Law Offices of
DENNIS W. BEECH

Serial No.:	10/027,391
Applicant:	C. Earl Woolfork
Filing Date:	12/21/2001
Group Art Unit:	2644
Examiner:	McChesney, Elizabeth A.
For:	WIRELESS DIGITAL AUDIO SYSTEM

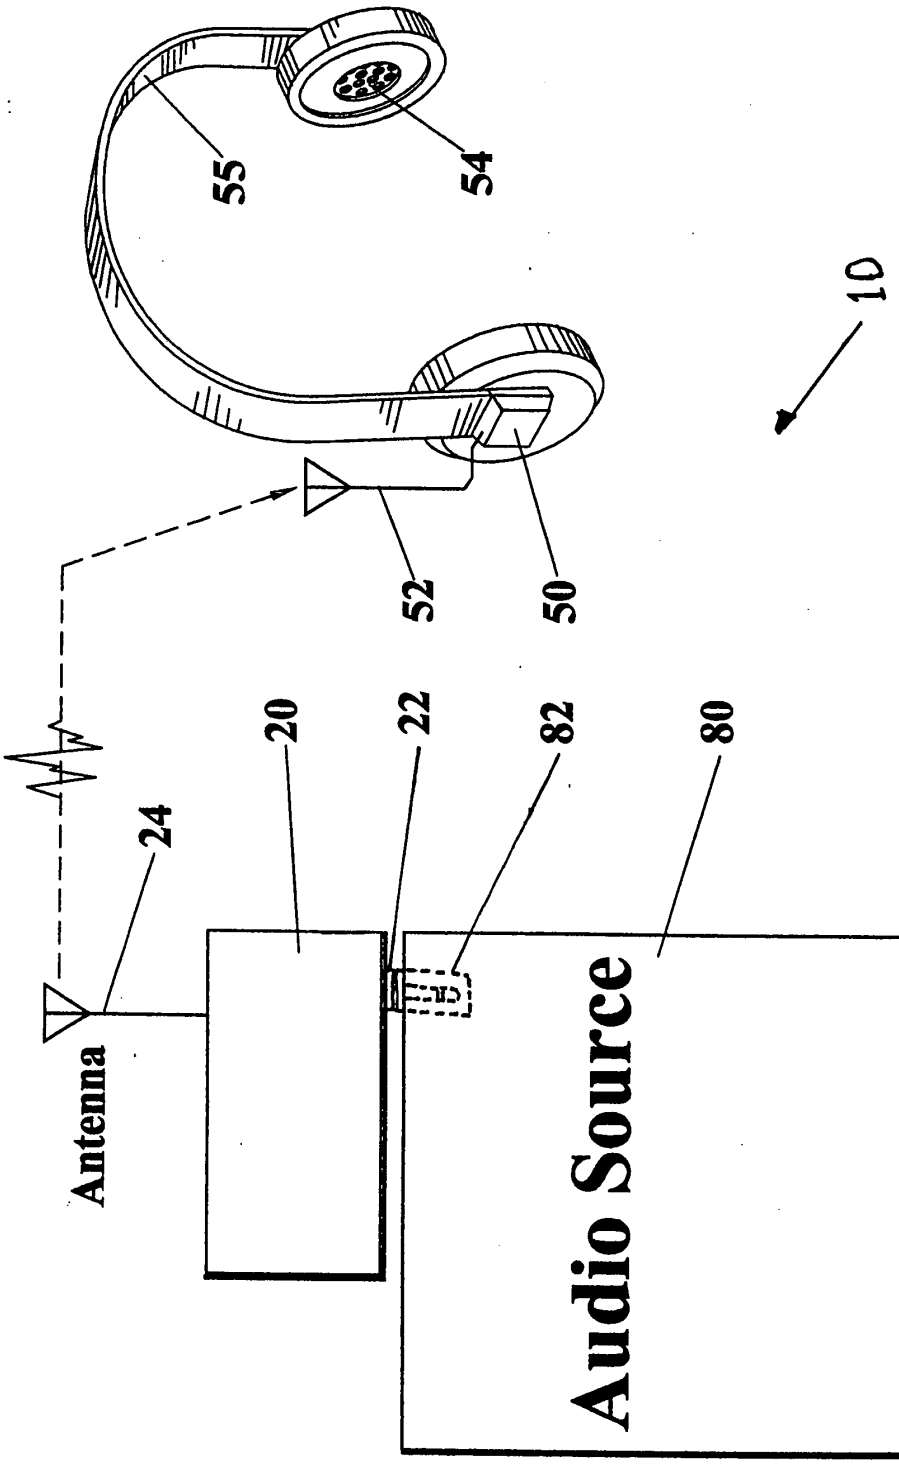
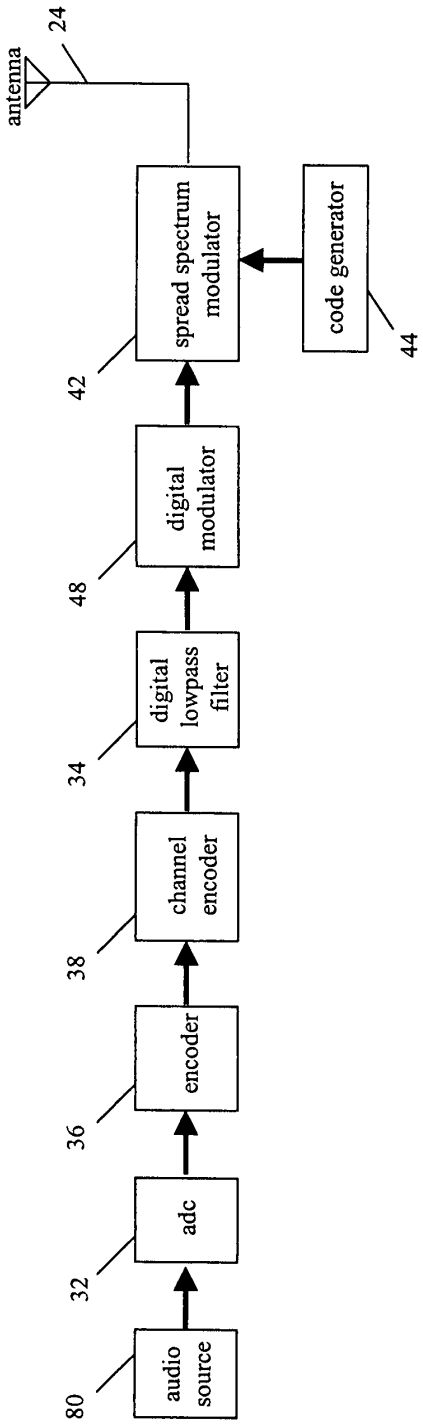
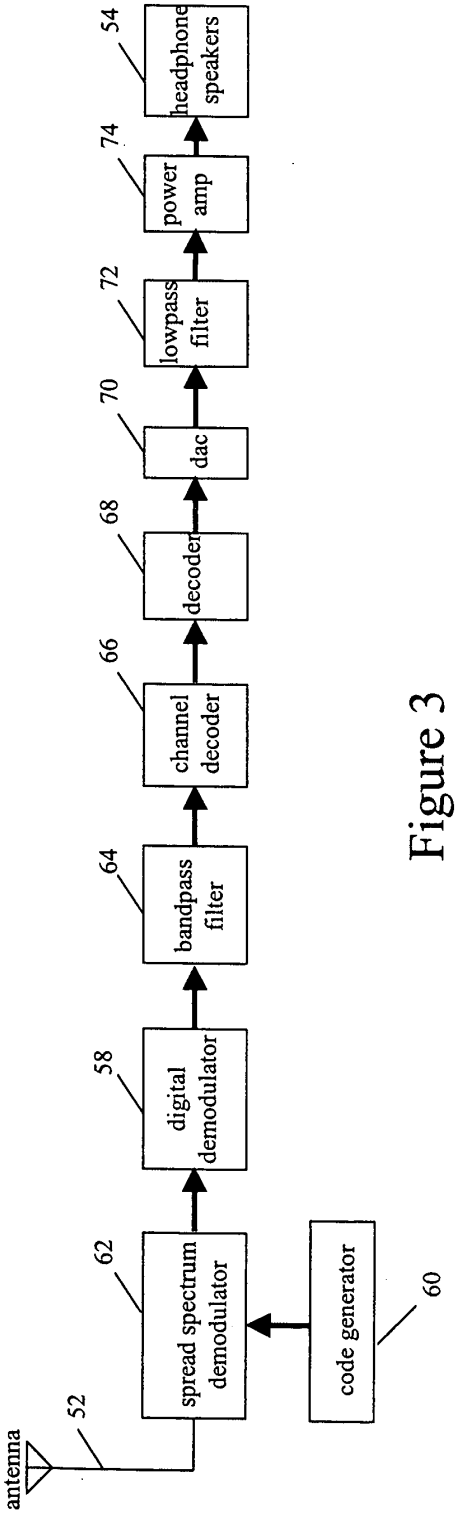
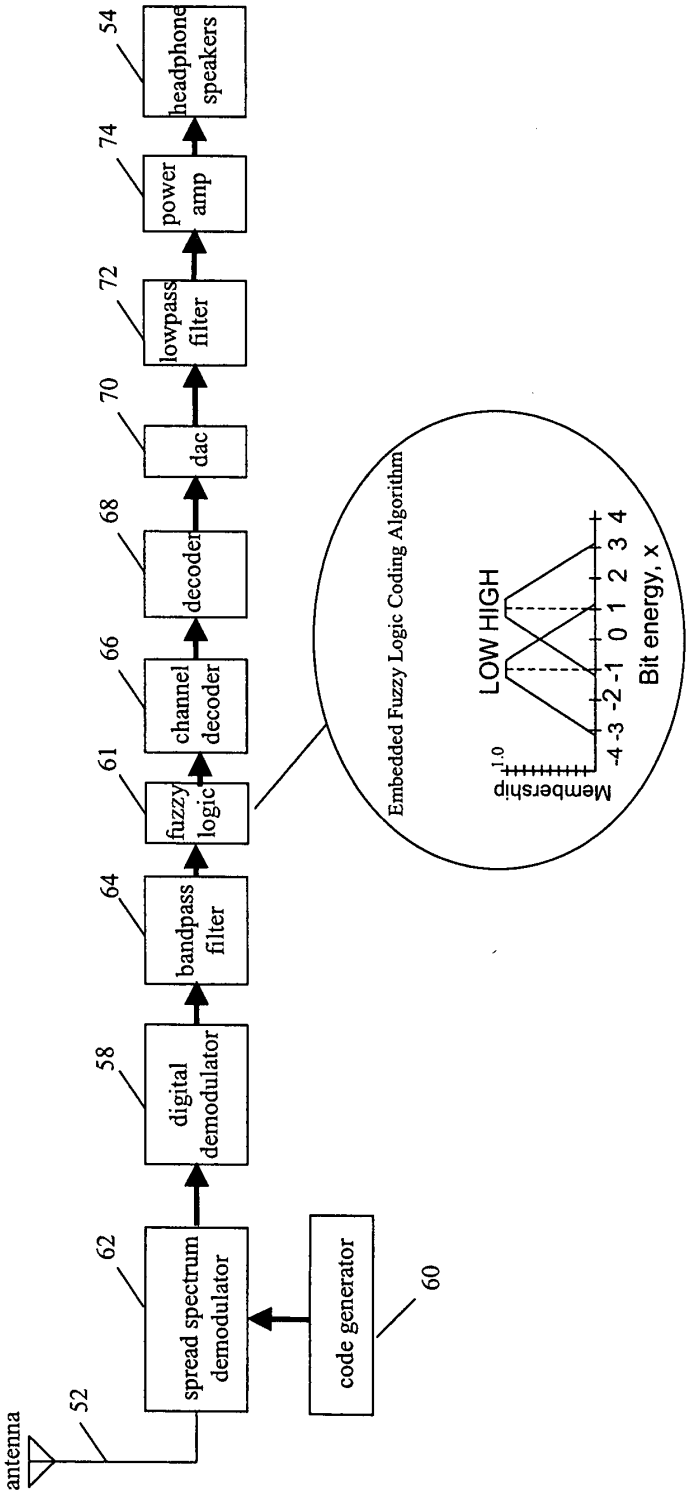
3. The drawings are objected to under 37 CFR 1.83(a). The drawings must show every feature of the invention specified in the claims. Therefore, each of the components recited in the claims, such as the codec, Bluetooth front end, shift register generator, encoder, decoder, modulator, demodulator, decoder, fuzzy logic system, as well as the steps of the methods, such as the receiving of a BLUETOOTH compliant packet, activating a fuzzy logic "if" rule, activating a fuzzy logic "then" rule, and performing a defuzzifying operation must be shown in the drawing or the feature(s) canceled from the claim(s). No new matter should be entered.

The attached sheets of drawings include corrections made to original Figures 1 and 2, the renumber of Figure 2 to Figure 4, and the addition of Figures 2 and 3 based on the examiner's comments. These sheets replace original sheets 1 and 2.

Figure 2

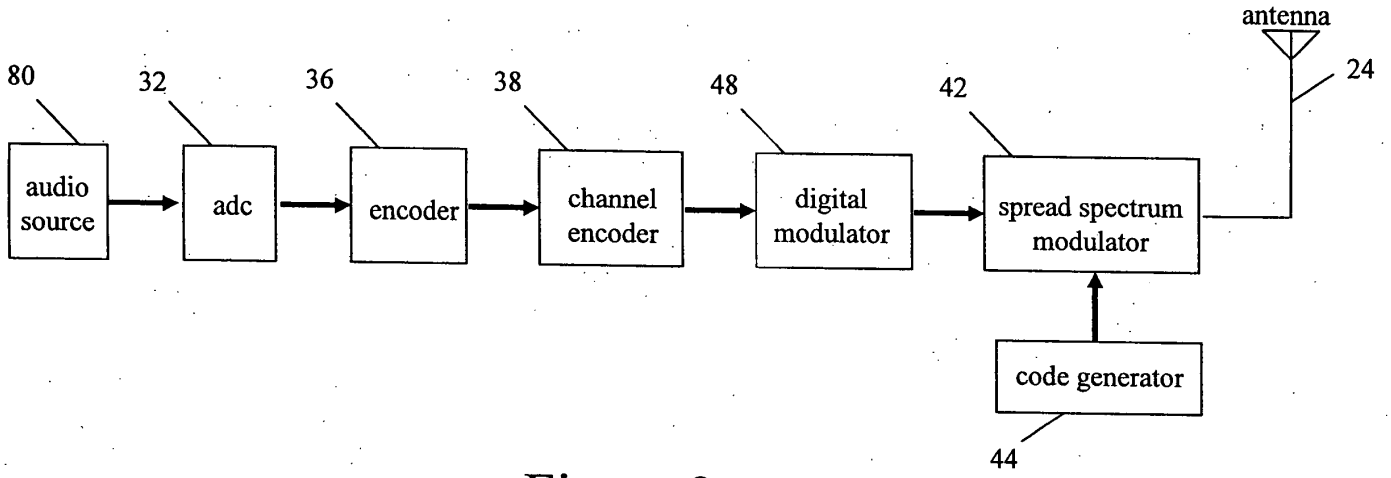
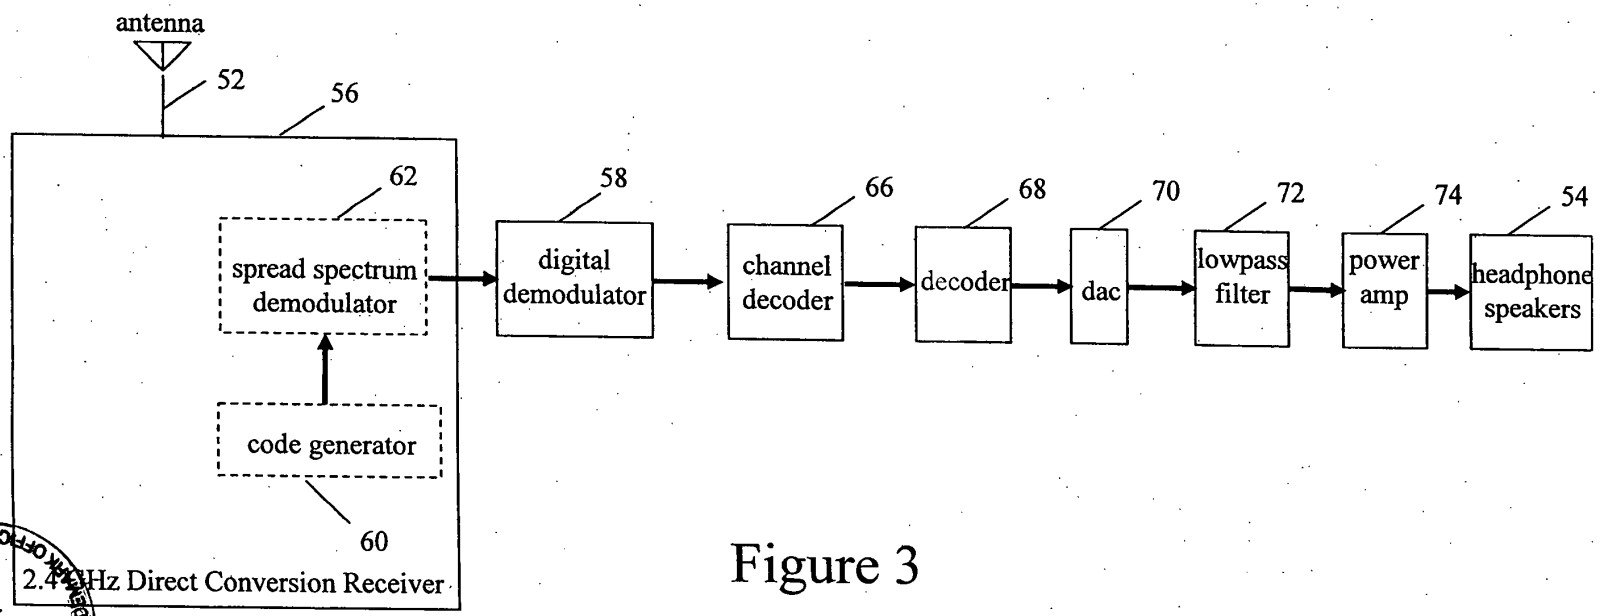
New corrected drawings in compliance with 37 CFR 1.121(d) are required in this application because Figure 2 incorporates new matter, which is prohibited by 37 CFG 1.121(f).

The drawings submitted 17 March 2006 show the code generator (60) and spread spectrum demodulator (62) integrated to form the direct conversion receiver 56. A 2.4 GHz direct conversion receiver is not previously disclosed including these two elements as shown in the present drawings and thus create a new matter situation. A direct conversion receiver (56) is shown in the parent application's drawings (Fig. 3

Figs. 1 - 3 have been amended and are believed to be in compliance with 37 C.F.R. 1.152. Specifically, Fig. 1 has been amended to show embedded fuzzy logic detection sub-system **61** and to correct reference numeral **54** (headphone speakers) to **75**. Reference numeral **54** corresponds to wideband bandpass filter (BPF) – see par. **[0015]** of parent patent application publication US 2003/0118196 A1. A replacement sheet containing amended Fig. 1 is submitted herewith as Exhibit 1 pursuant to MPEP 608.02(t). Figs. 2 – 3 have been amended to identify each component block, respectively, consistent with the specification. Reference numeral **54** designating the headphone speaker(s) has been corrected to **75**. A replacement sheet containing amended Figs. 2 - 3 is submitted herewith as Exhibit 2 pursuant to MPEP 608.02(t).
